Please submit claim via our Online Warranty System, available at [www.prevostcar.com](http://www.prevostcar.com) (under service \ warranty section). Use Claim Type: "Bulletin/Recall" and select "Safety Recall SR14-26".

VBC Bulletin	n/a
Fail Code	18.03-2
Defect Code	09
Syst.Cond.	R
Causal Part	864115

Figure 3: Typical belt damage (Curb side seat)

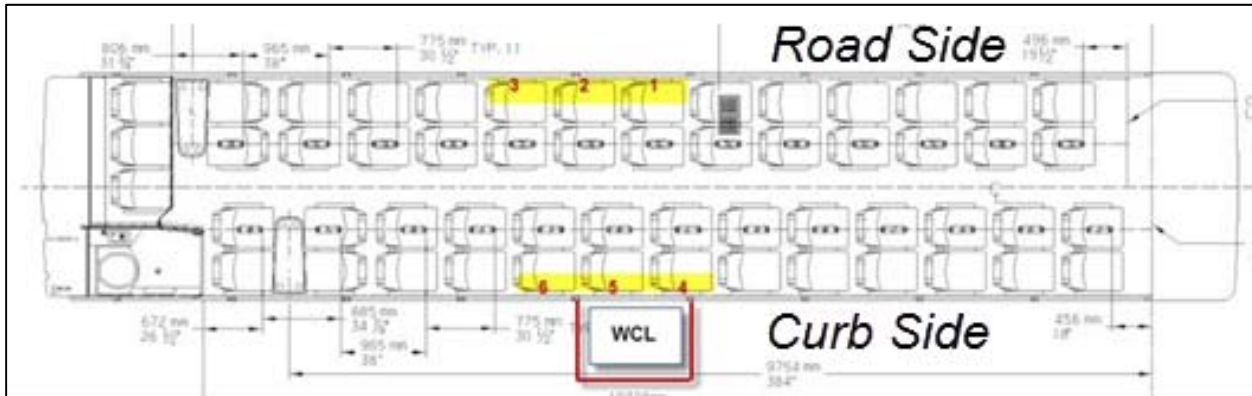
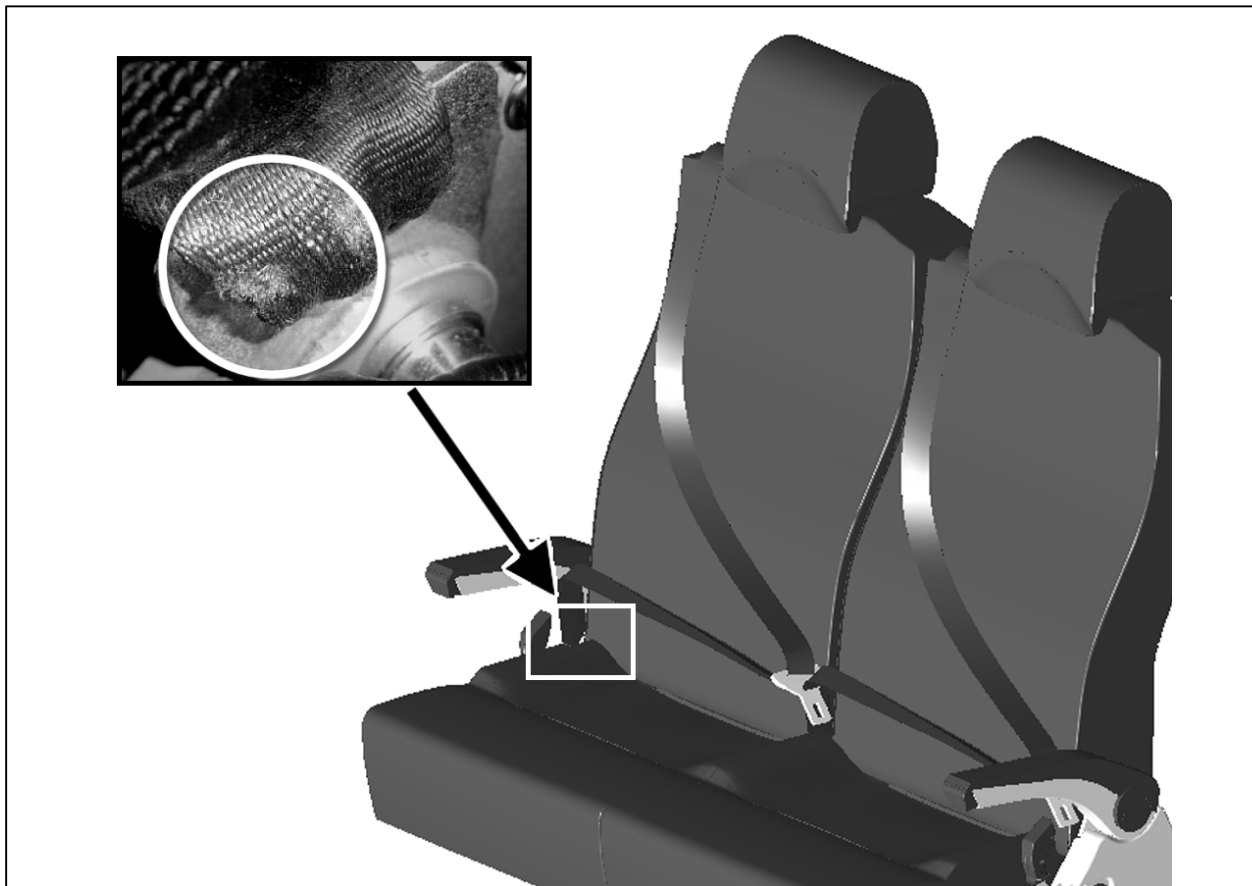
The outboard (wall side) seat belt anchor of all flip-up seats must be inspected for damage. (fig 2 & 3).

**Note:** the damage to the belt can sometimes be hard to see. Use a flash light, if necessary and expose the underside of the belt that is located in and around the anchor loop.

Figure 5: Typical Damaged belt

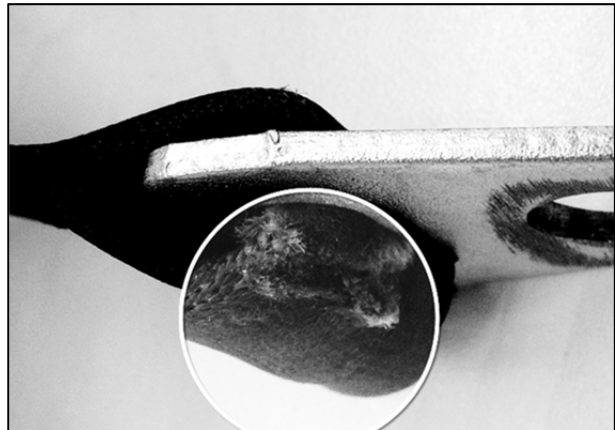
If it is damaged (Fig 5), replace with a new belt.

For Torino G models, order kit SR14-26-1.

For A210 models, order kit SR14-26-2.

Order one kit per belt to replace.

Figure 10: New position of belt anchor.

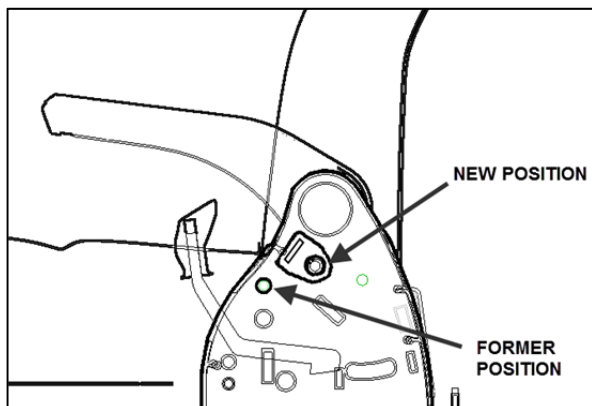
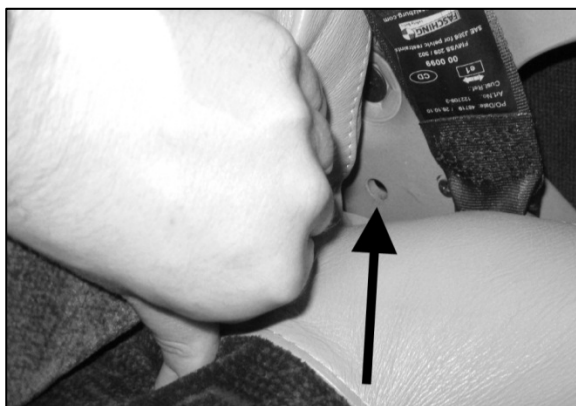
7. Re-install belt anchor in new location as shown, away from pivot. (Fig 10 & 11)

8. Belt anchor plate should be installed parallel to seat frame.

Install with:  
5001734 Screw  
500897 Washer  
500594 Nut

**Tighten to:35 lbf-ft**

Figure 12: New hardware and torque seal

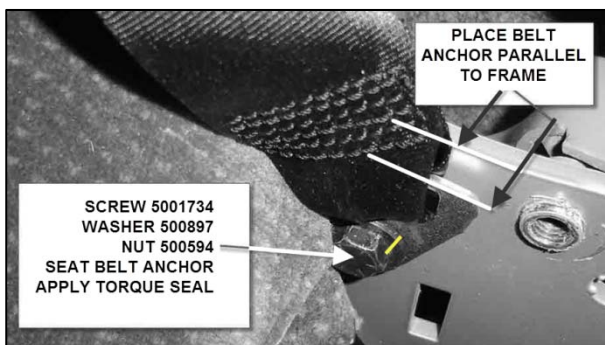
Apply torque seal mark to confirm belt relocation. (Fig 12)
